ADVISORY
 BULLETIN

No. 2000-06

Wire Harness Shunt Resistor – 25, 30/40/40 Bigfoot (4-Stroke)

877860T1 Wire Harness Shunt Resistor

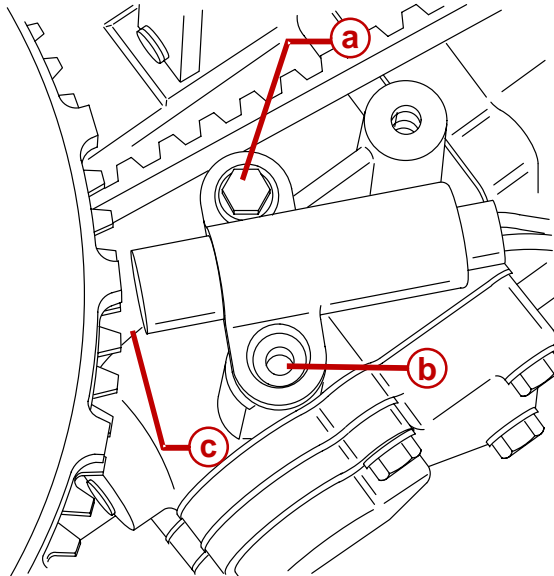
Some engines that exhibit a mid to high speed mis-fire may require the installation of a wire harness shunt resistor. The mis-fire is caused by a combination of ignition components that prematurely activate the rev limiter function. Due to the fact that a specific combination of components is required, not every engine that exhibits the mis-fire will require the installation of the shunt resistor. It is important to inspect basic ignition and fuel related components that could cause this similar characteristic.

After the serial numbers listed, 2000 model year product has the wire harness shunt resistor installed during assembly. 2001 model year product has a new ECM that corrects the problem and the wire harness shunt resistor is not installed.

58140

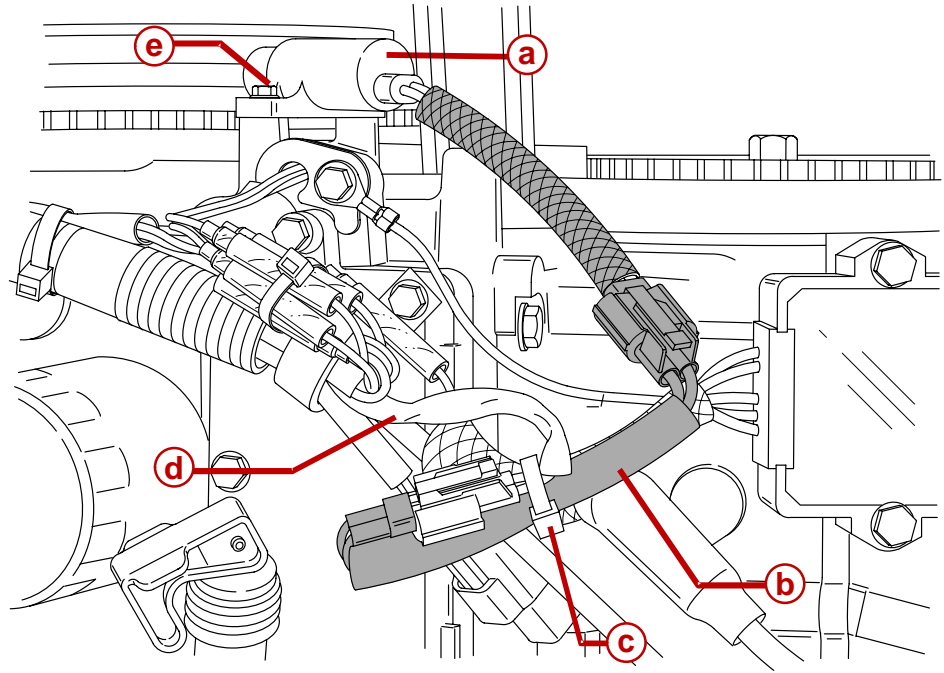
If the engine exhibits a “miss” in the rpm range from 2000 rpm to wide open throttle (WOT), a simple test can be performed to determine if the wire harness shunt resistor will remedy that particular problem. Remove one of the crank position sensor mounting bolts. Loosen the remaining bolt and reposition the sensor to achieve an approximate flywheel to crank sensor air gap of 0.125 inch (3.18 mm). Retighten the one bolt to retain the sensor position.

Rerun the engine and determine if the miss is still present.

If the miss is still present: The installation of the wire harness shunt resistor will not remedy the situation. It will be necessary to troubleshoot the ignition and fuel system.

If the mis-fire is not present: Install the wire harness shunt resistor at the crank position sensor terminal. Install a sta-strap to retain the wire harness.

Reposition the crank position sensor, install the bolt removed, and tighten the mounting bolts. Crank position sensor mounting bolt torque - 45 lb. in. (5.1 N·m).
